FINDINGS OF FACT AND FINAL ORDER TYPE II LAND USE DECISION

DATE OF DECISION:	March 21, 2025
FILE NO.:	24-059 DR
PROJECT NAME:	Deer Pointe Park
APPLICANT/OWNER:	Rochelle Anderholm-Parsch/City of Sandy
ADDRESS:	18200 Meadow Drive
MAP/TAX LOT:	25E18CC 13400 and 25E18CD 01600
SIZE OF PROPERTY:	3.16 acres
ZONING:	Parks and Open Space (POS)
STAFF CONTACT:	Patrick Depa, Senior Planner

(Figure 1)

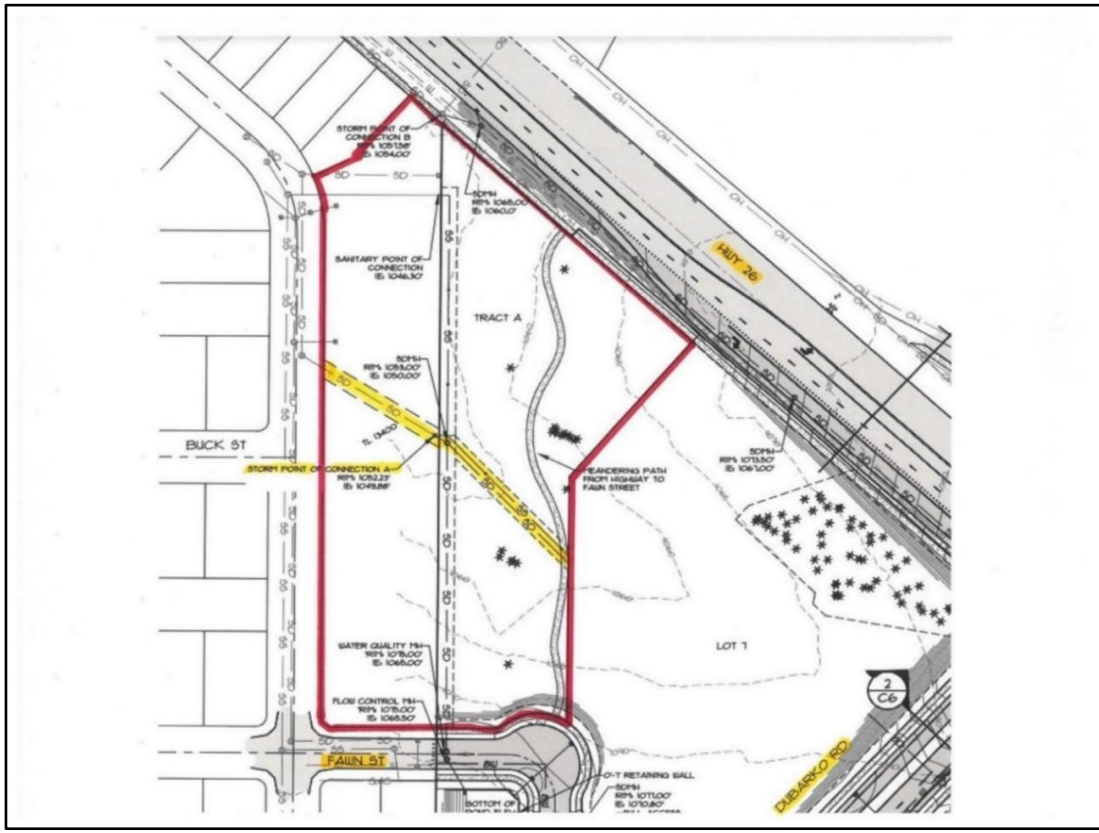
Finding 2. Tax Map/Lot 25E18CC13400 has a recorded 15-foot-wide storm drain easement that is designed to connect and transverse the park dedication associated with the approval for Bull Run Terrace (see Figure 1). The 25E18CC13400 parcel shows also has a dry sanitary sewer line through the north part of the parcel, but no legal easement has been identified. **Easements will need to be recorded if any utilities through Deer Pointe Park are private, but public utilities do not require an easement through public land. All future private utility easements shall be recorded when finalized.**

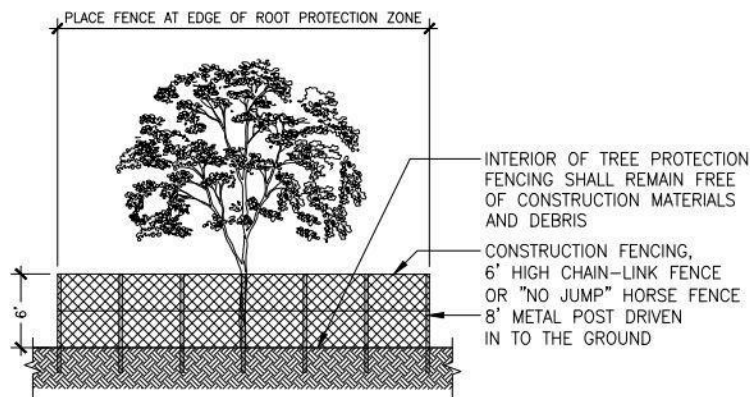
tree retention plan (Sheet L0.01) with two trees for removal (tree tags #13096 and #15500) that the Bull Run Terrace Subdivision approval included for retention. Tree #13096 was defined as an 11-inch Douglas fir in good condition and Tree #15500 was defined as a 34-inch Douglas fir in good condition. These two trees need to be removed for planned park improvements.

In-lieu of removing the two tree retention trees, the applicant proposes to retain four additional trees that the Bull Run Terrace Subdivision approval did not include. These trees were tagged by the Bull Run Terrace applicant as Tree #13538 (39-inch western red cedar in good condition), #13539 (32-inch Douglas fir in good condition), #13540 (37-inch western red cedar in good condition), and an 8-inch western red cedar that was not tagged by the Bull Run Terrace applicant. **The trees that were defined for retention with the Bull Run Terrace Subdivision approval shall be retained, except for Tree #13096 and #15500. The applicant shall retain trees #13548, #13539, #13540, and an 8-inch western red cedar that was introduced with this application in-lieu of removal of #13096 and #15500.**
